RS-15-144

U.S. Nuclear Regulatory Commission  
ATTN: Document Control Desk  
Washington, DC 20555-0001Quad Cities Nuclear Power Station, Units 1 and 2  
Renewed Facility Operating License Nos. DPR-29 and DPR-30  
NRC Docket Nos. 50-254 and 50-265

Subject: Additional Information Supporting Relief Request I4R-20, Inservice Inspection Program Relief Request Regarding Examination Coverage for the Fourth Inservice Inspection Interval

BMR-016-295 - 83% coverage

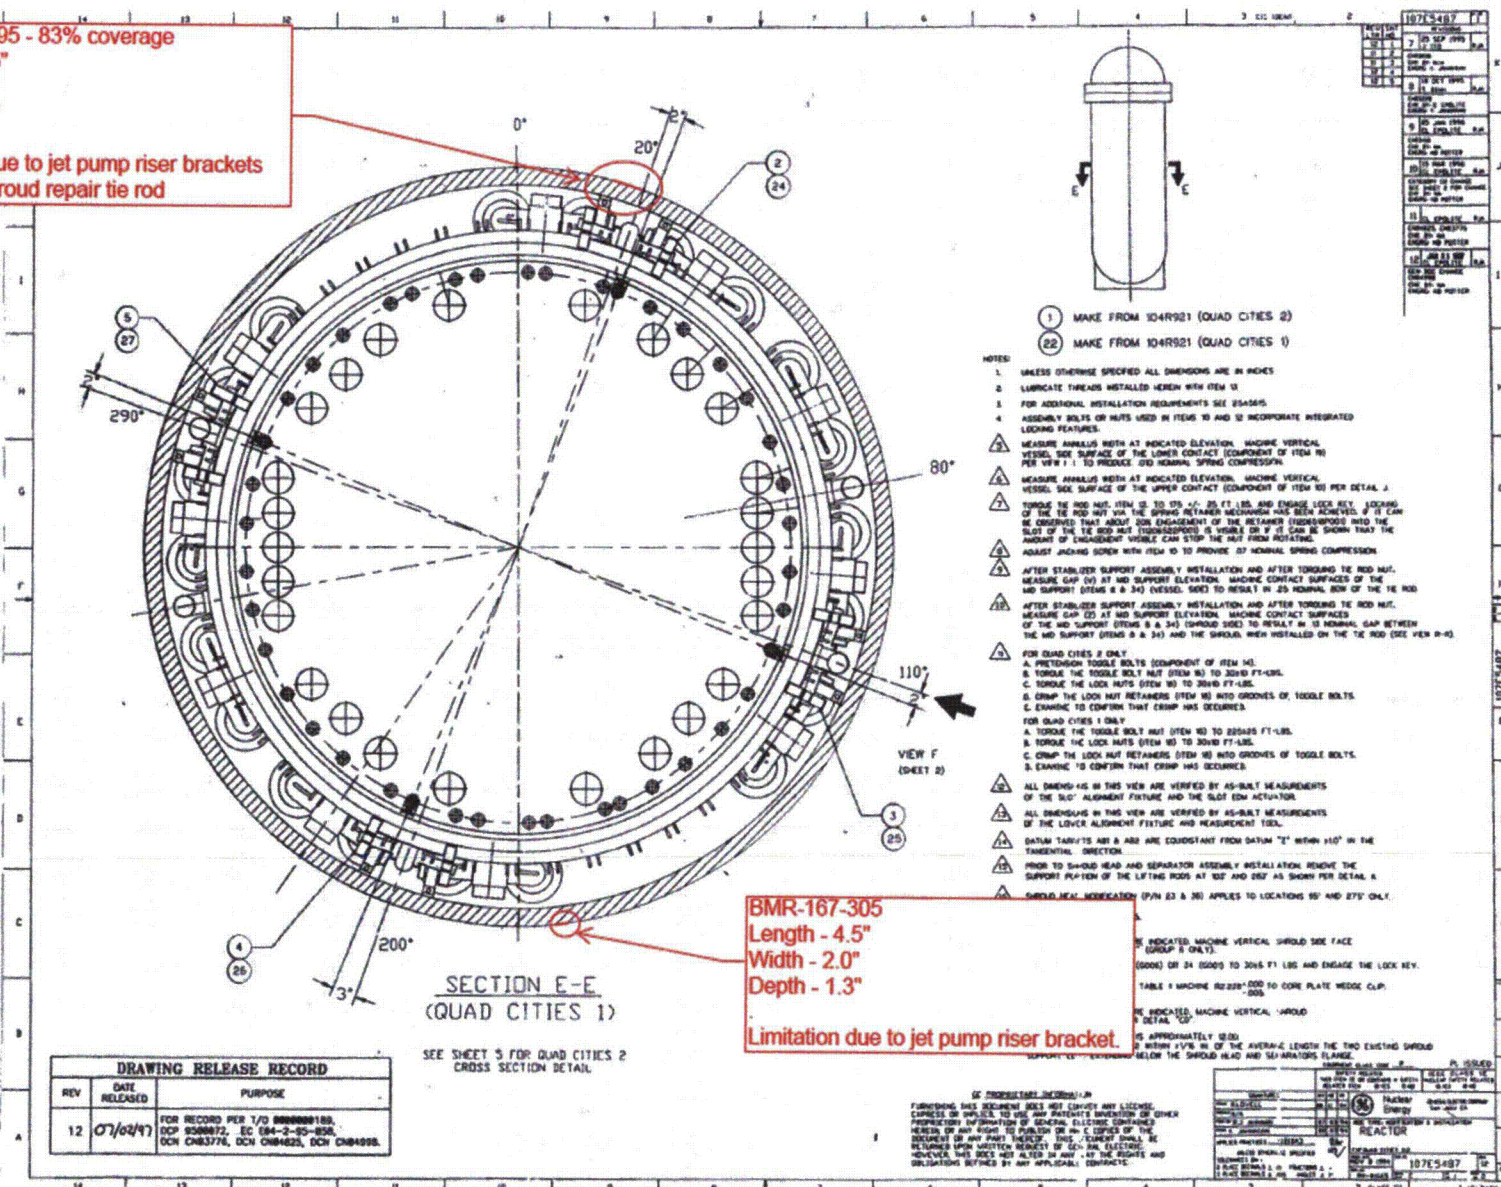
Provide coverage plots for all RPV beltline repair welds listed in Table 2.1.1 above. From the coverage records provided in the licensee's RAI response, it is difficult to tell which areas have been covered.

Weld BMR-016-295 received 83.0% coverage in the 2005 exam. Limitations were due to jet pump riser brackets and a core shroud repair tie rod. This is an increase of 83% coverage from the previous interval's inspection due to the use of a different tool. Weld BMR-167-305 received 87.0% coverage in the 2005 exam. Limitations were due to a jet pump riser bracket. This is an increase of 7.5% coverage from the previous interval's inspection due to the use of a different tool. Drawings showing the location of the beltline repair welds and optimal coverage plots are provided below.

Limitation due to jet pump riser brackets  
and core shroud repair tie rod
